Critical Area Commission

STAFF REPORT

July 1, 2026

APPLICANT:	Washington Suburban Sanitary Commission
PROPOSAL:	Anacostia Depot Reconfiguration
JURISDICTION:	Prince George's County
COMMISSION ACTION:	Vote
STAFF RECOMMENDATION:	Approval with Condition
STAFF:	Katie Hayden
APPLICABLE LAW/ REGULATIONS:	COMAR 27.02.06 Conditional Approval of State or Local Agency Programs in the Critical Area

On-site Planting

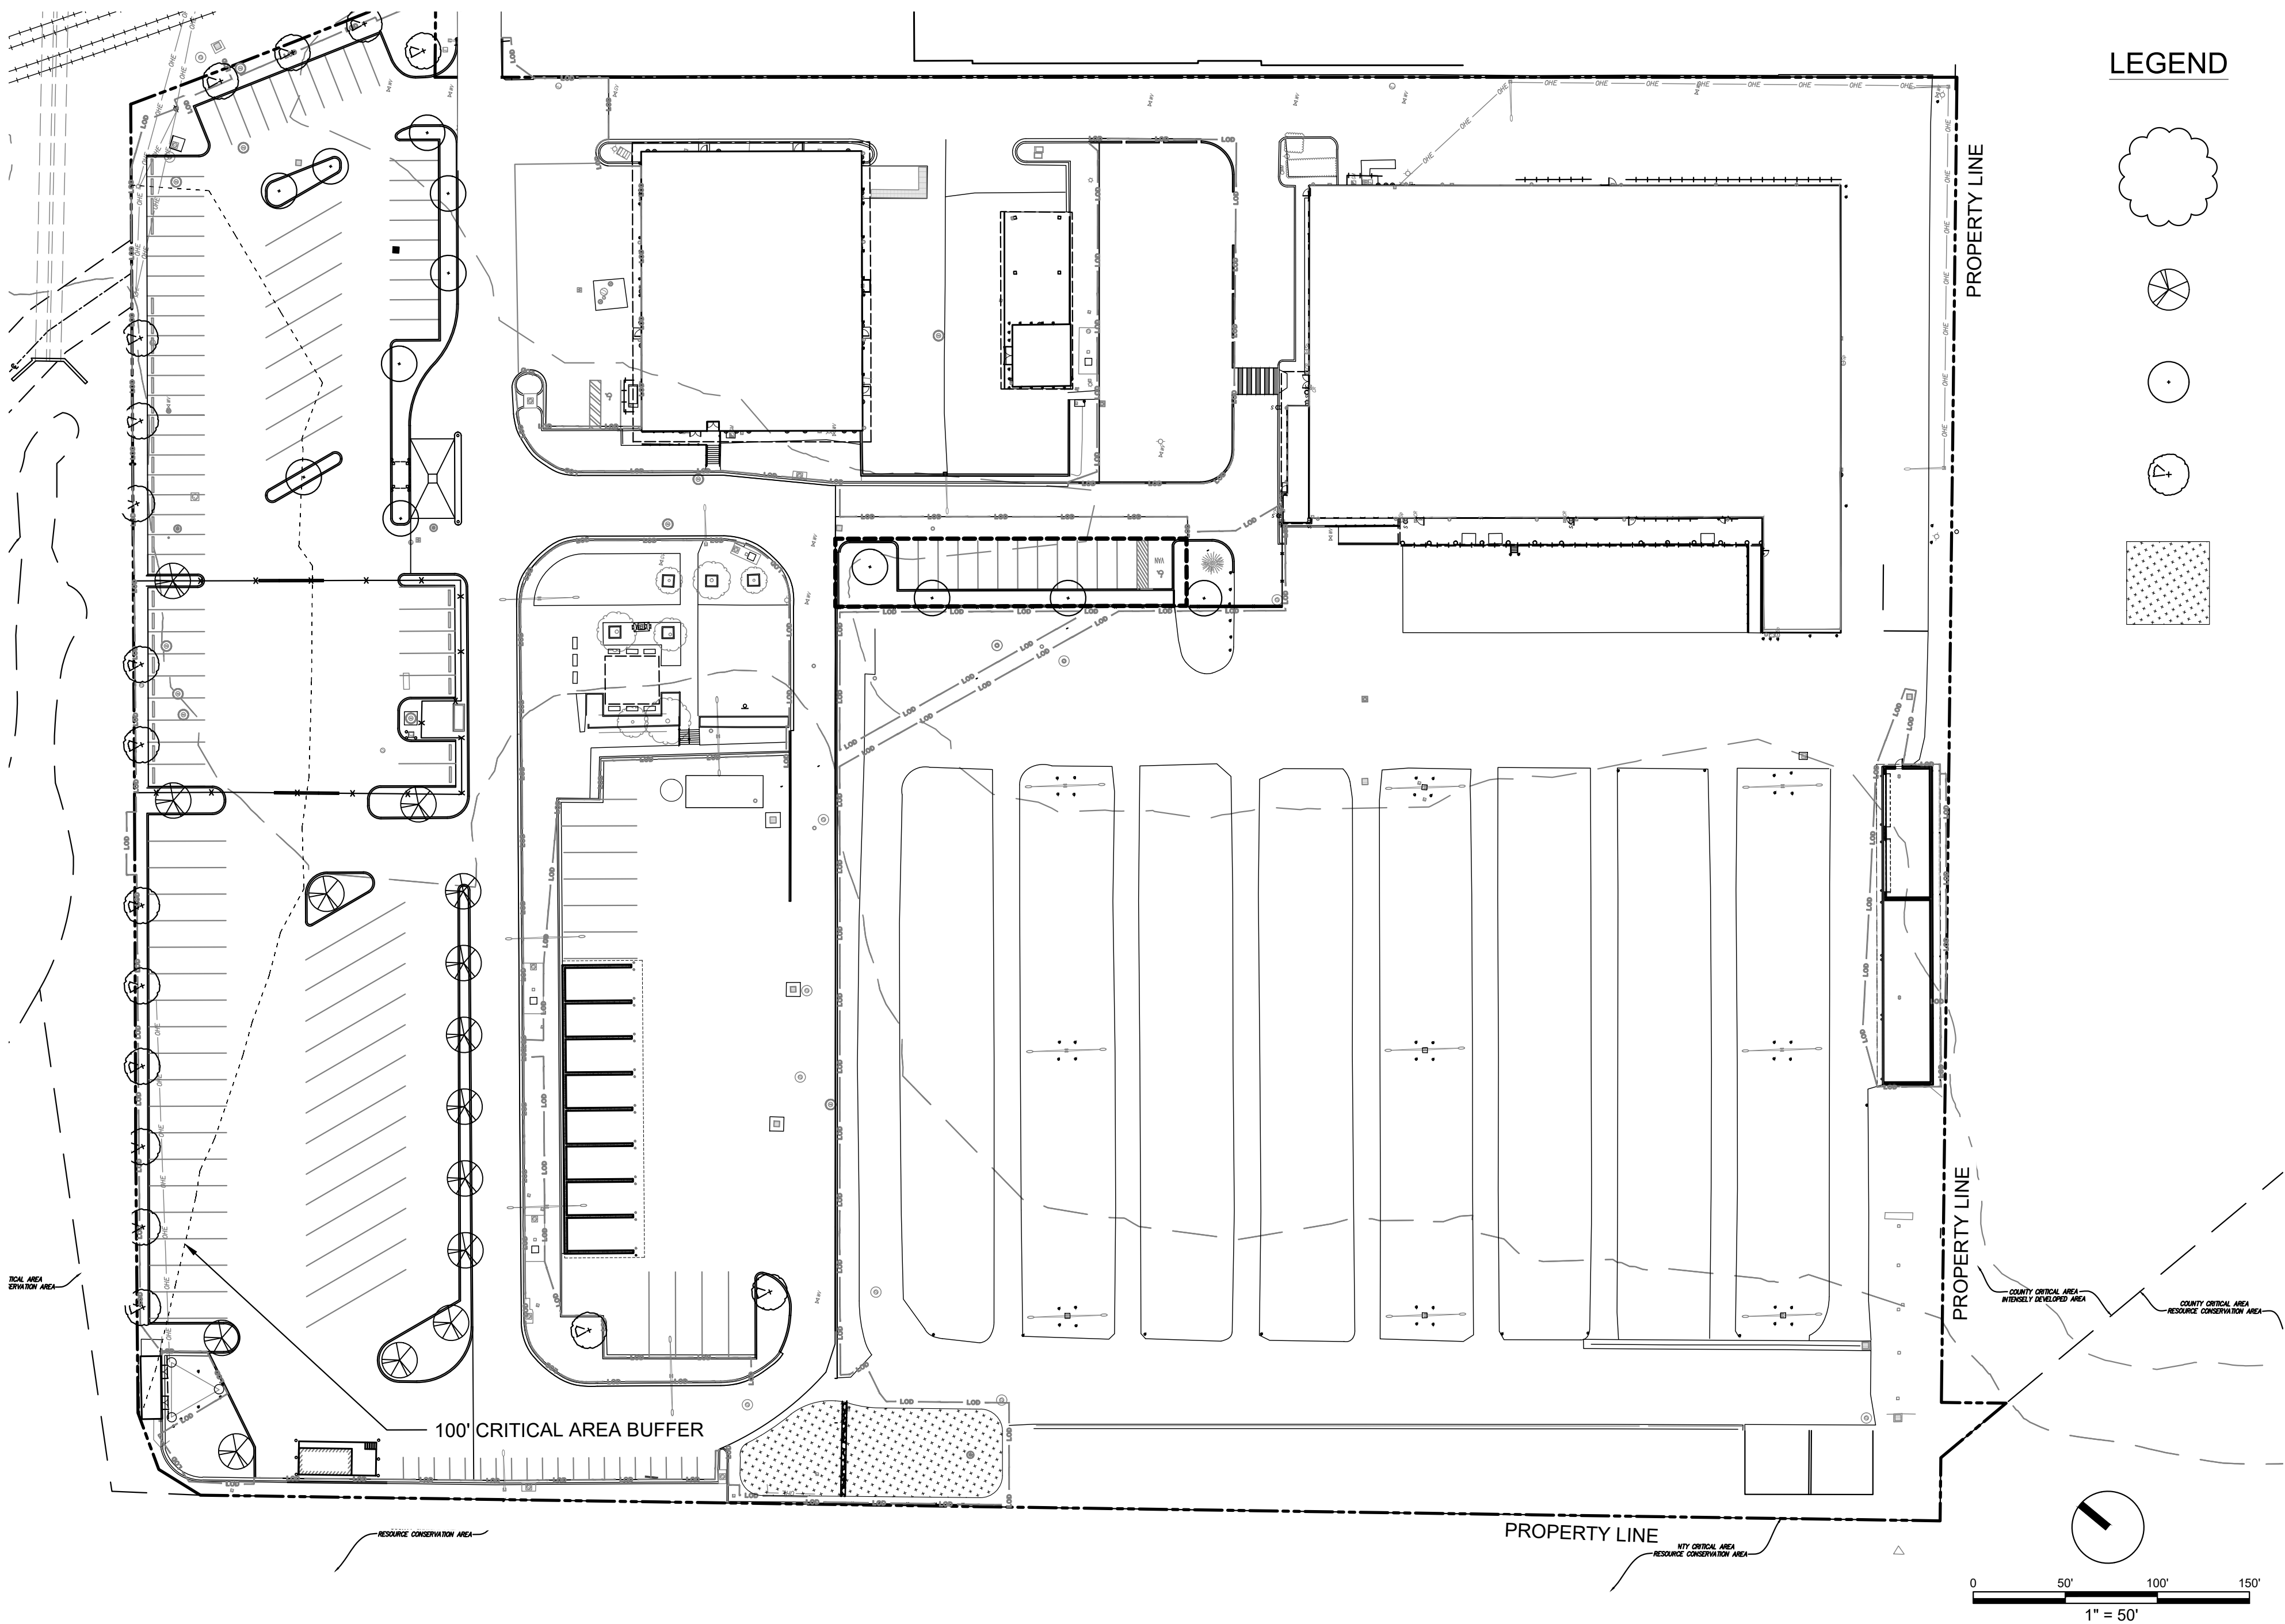
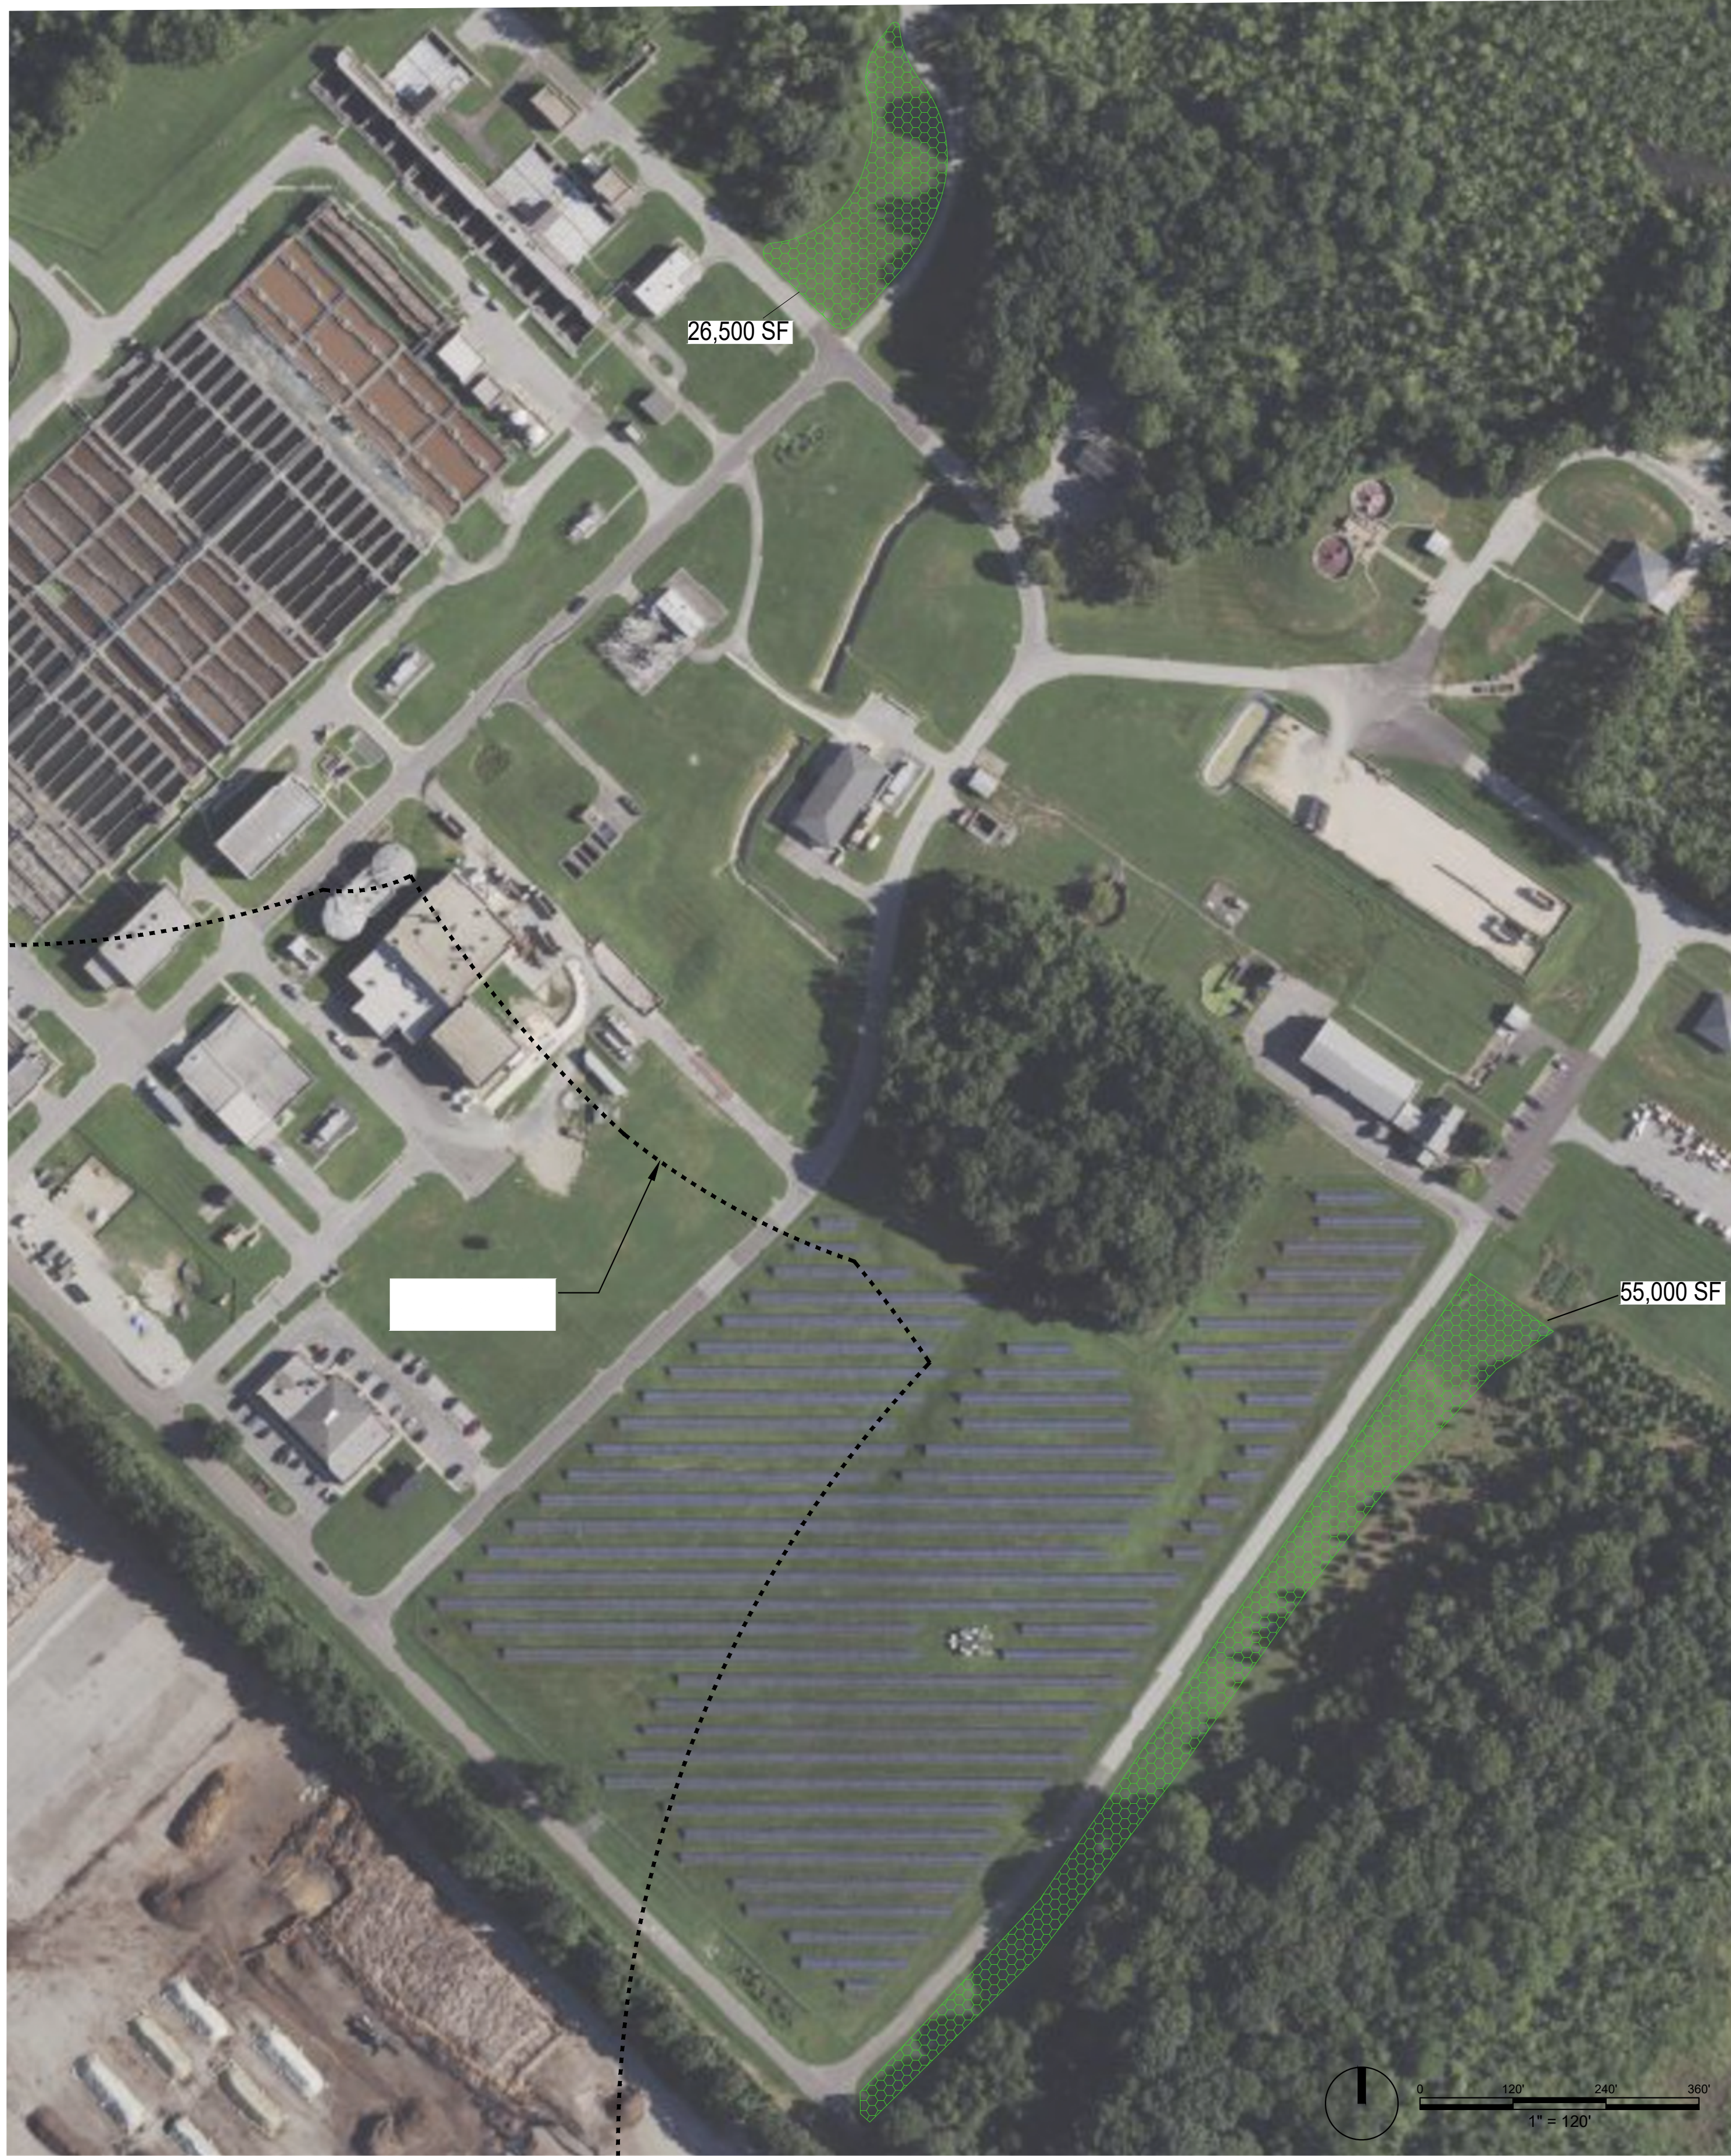
- The location of proposed stormwater features located in the floodplain;
- The extent of impervious surface and parking in the floodplain and the Critical Area Buffer;
- The inclusion of nonnative and invasive species in the initial landscape plan.

Since the Project Committee meeting, WSSC revised the onsite planting plan to replace non-native and invasive species with native species. Critical Area Commission staff, in consultation

- Invasive and non-native plant species were removed and replaced with native plant species in the updated landscape plan (i.e., planting plan).
